Technical Service Bulletin

40 Clicking noise from wheel bearing

40 12 27 2024318/3 November 8, 2012. Supersedes Technical Service Bulletin Group 40 number 12-26 dated September 26, 2012 for reasons listed below.

Figure 1. Area to apply paste.

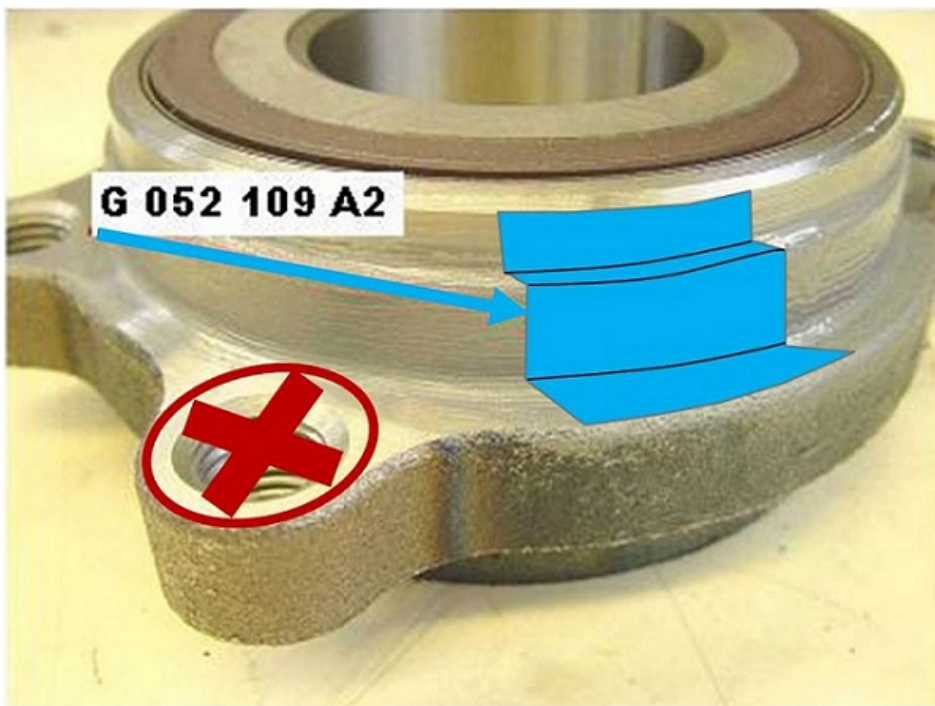
Clicking or clacking noise when maneuvering or parking.

Normal driving dynamics may cause microscopic movements between the wheel bearing and wheel bearing housing.

1. Remove any corrosion and dirt from the wheel bearing housing and the wheel bearing.
2. Using a brush, apply a thin coat of paste **G 052109A2** on the wheel bearing housing as shown in Figure 1. Make sure not to apply any paste on the threads.
